HERARD RESIDENCE  
INTERIOR & EXTERIOR  
RENOVATIONS &  
ADDITIONS

DRAWING TITLE  
**AMENDMENT TO THE  
PREVIOUSLY  
APPROVED SITE PLAN**

**HERARD RESIDENCE  
NEW ROOF DECK**

**DRAWING TITLE  
PROPOSED ROOF DECK  
PLANS & DETAILS**

3 PROPOSED SITE PLAN

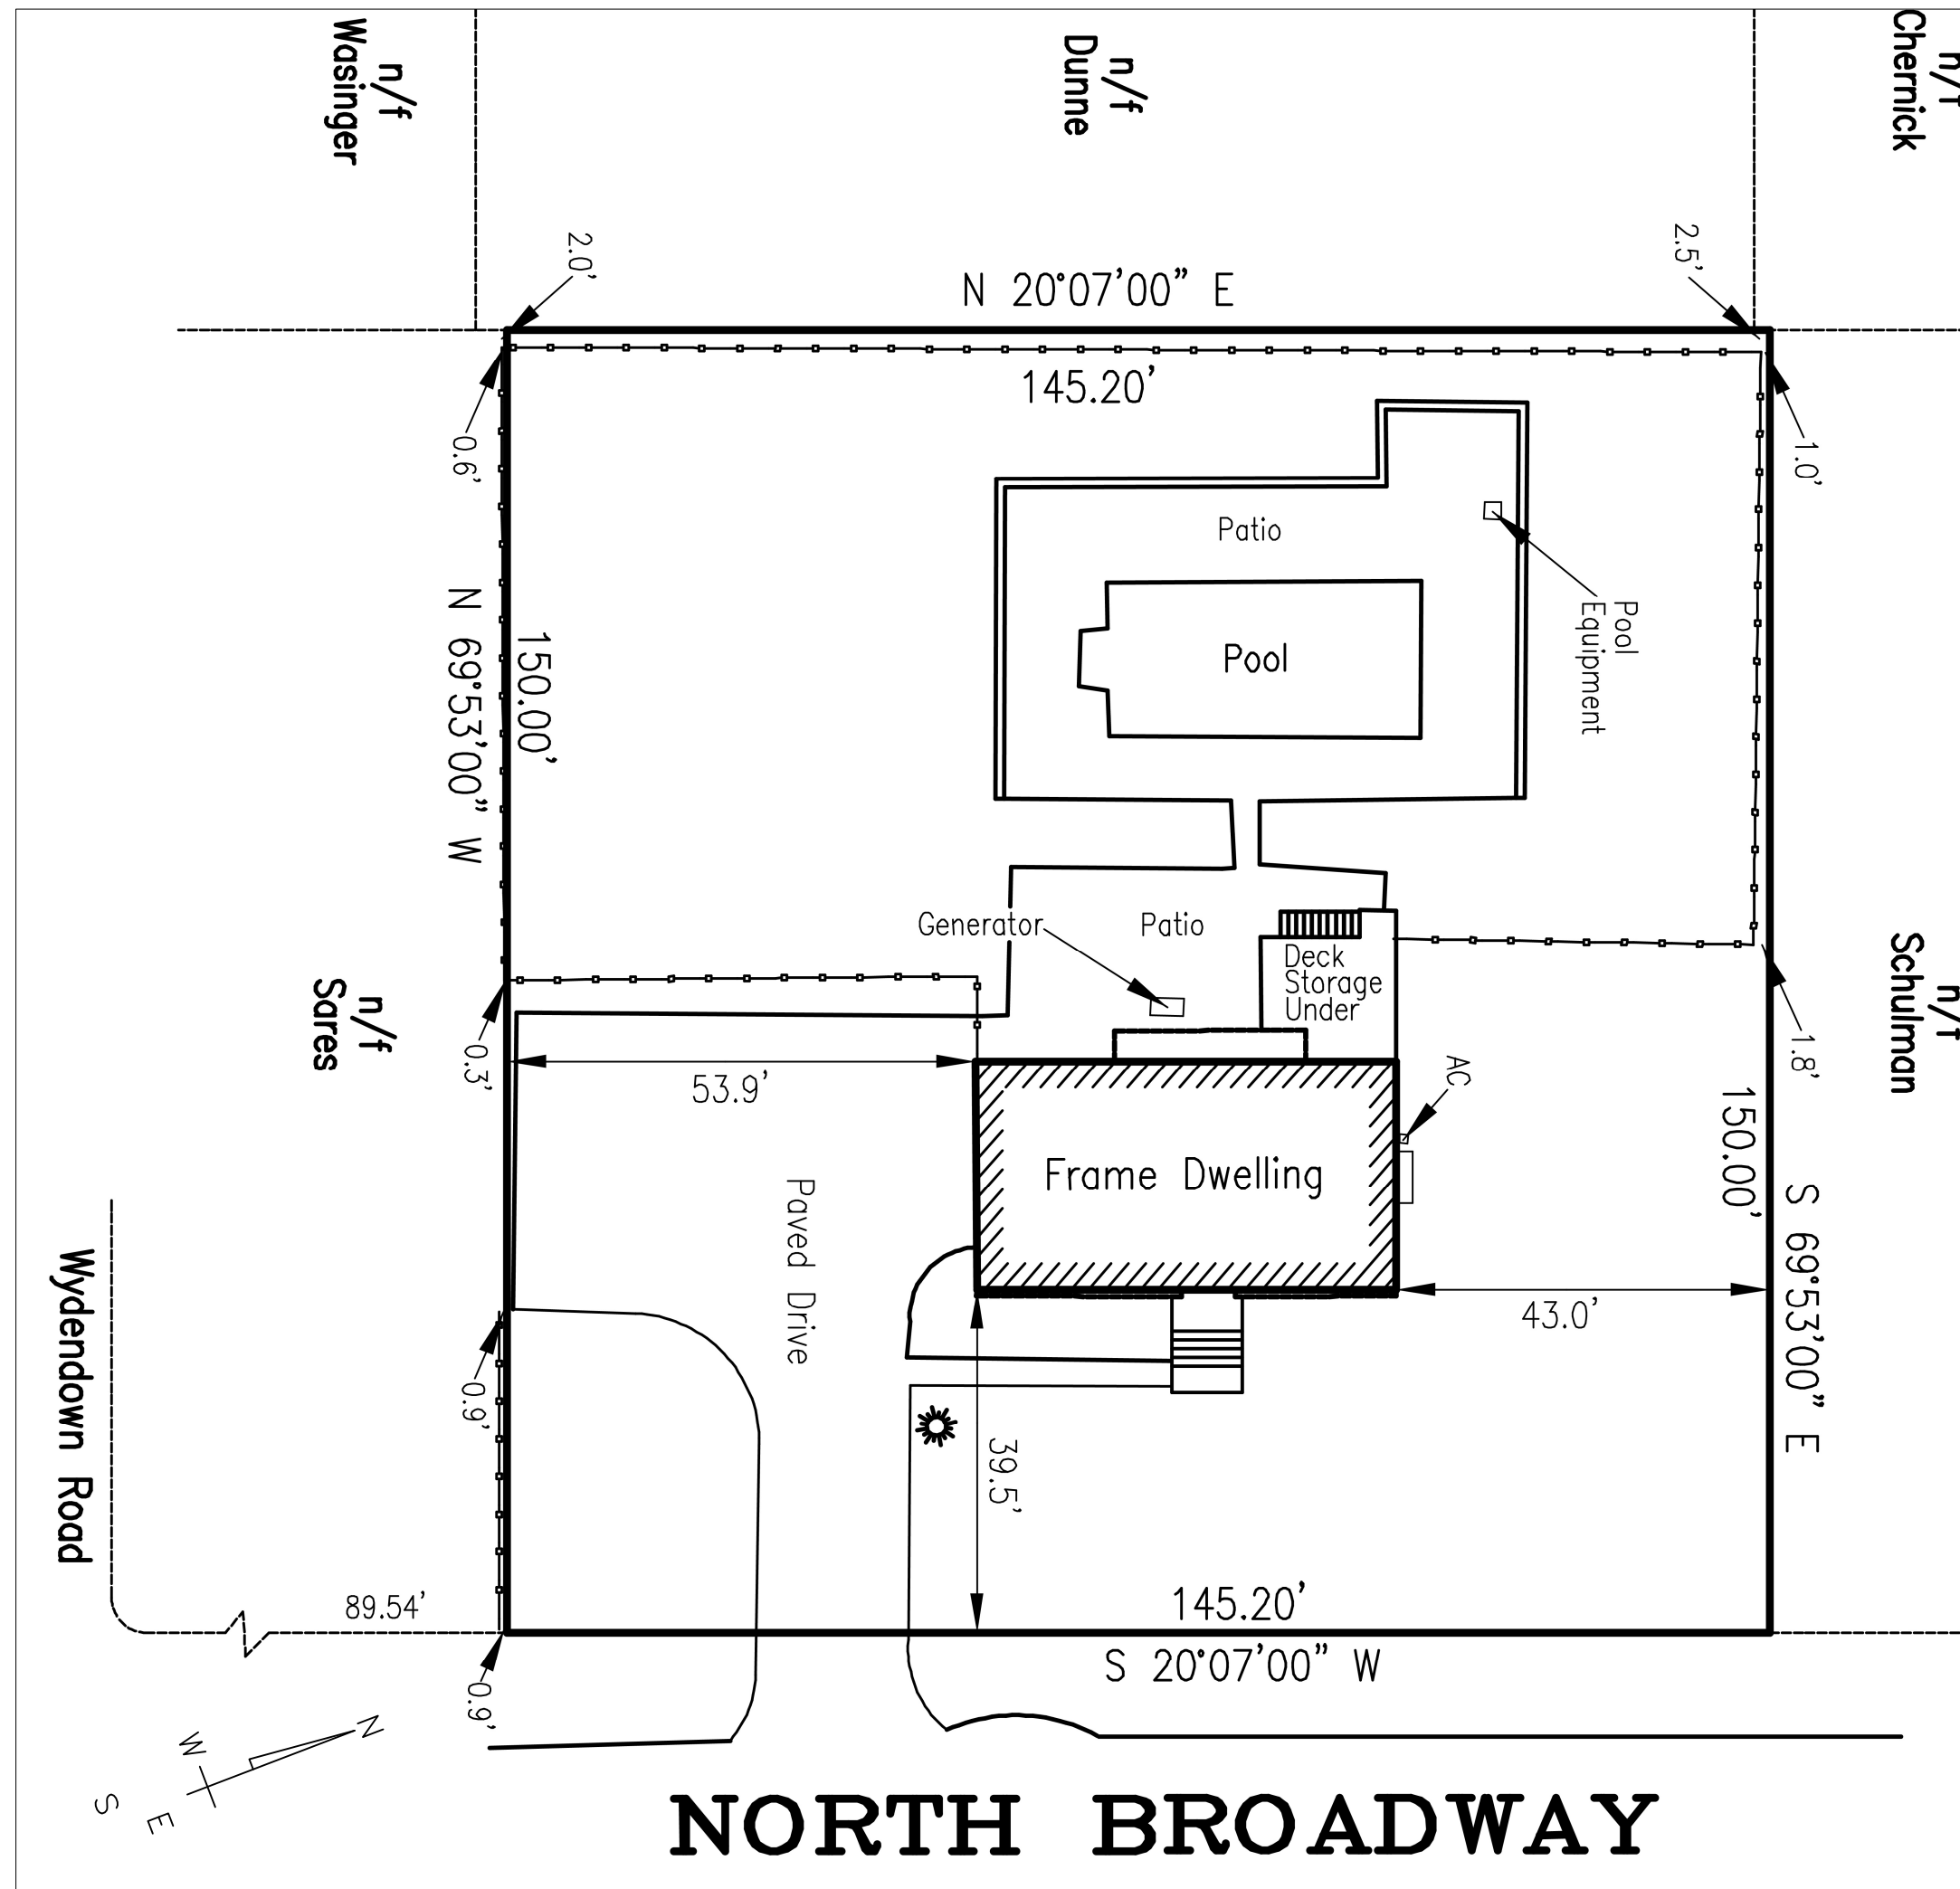
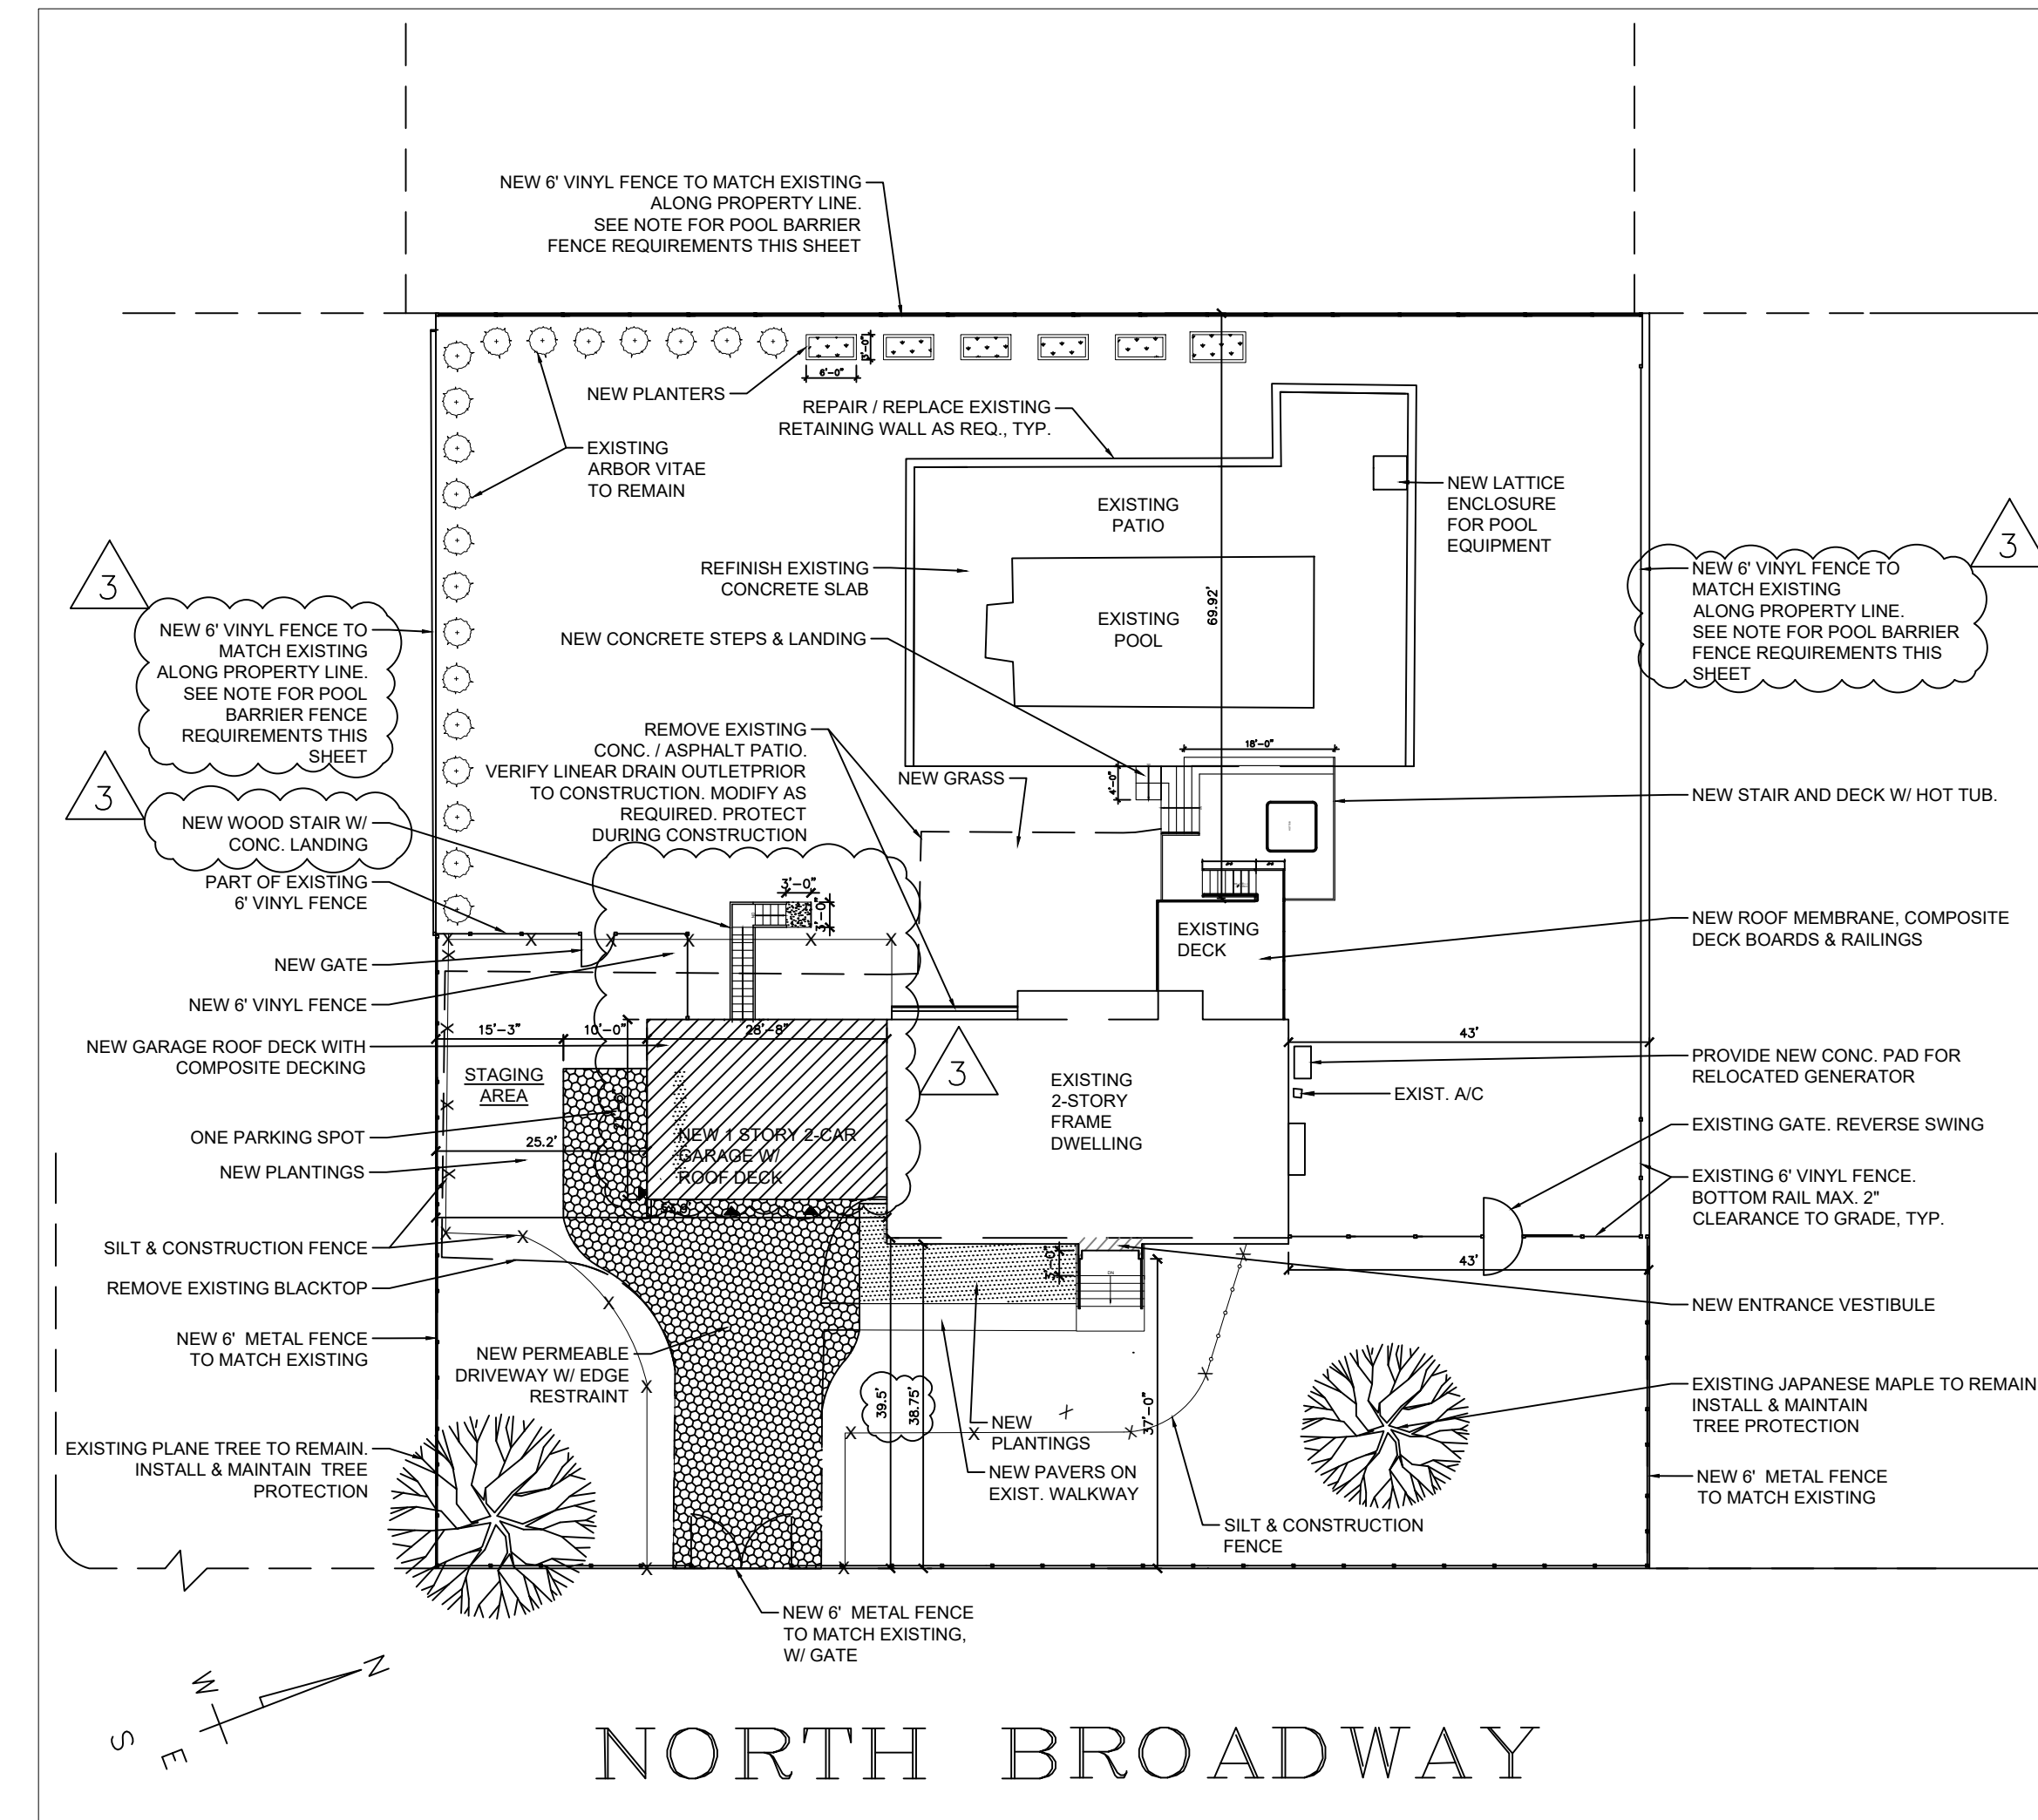
REVISION NOTE 1:  
THE PREVIOUSLY APPROVED SITE PLAN HAS BEEN REVISED TO SHOW A NEW DECK WITH HOT TUB AND A NEW STAIR TO REPLACE THE EXISTING BETWEEN THE POOL AND THE STORAGE STRUCTURE WITH THE EXISTING DECK ON TOP. THE PROPOSED SPIRAL STAIR HAS BEEN REPLACED WITH A WOODEN LINEAR STAIR IN THE SAME LOCATION AS THE EXISTING STAIR.

REVISION NOTE 2:  
THE PREVIOUSLY APPROVED SITE PLAN HAS BEEN REVISED TO SHOW A NEW ROOF DECK WITH SHADE STRUCTURE ABOVE THE NEW GARAGE AND A NEW SPIRAL STAIR TO THE BACK YARD. THE GENERATOR HAS BEEN MOVED TO THE NORTH SIDE OF THE HOUSE.
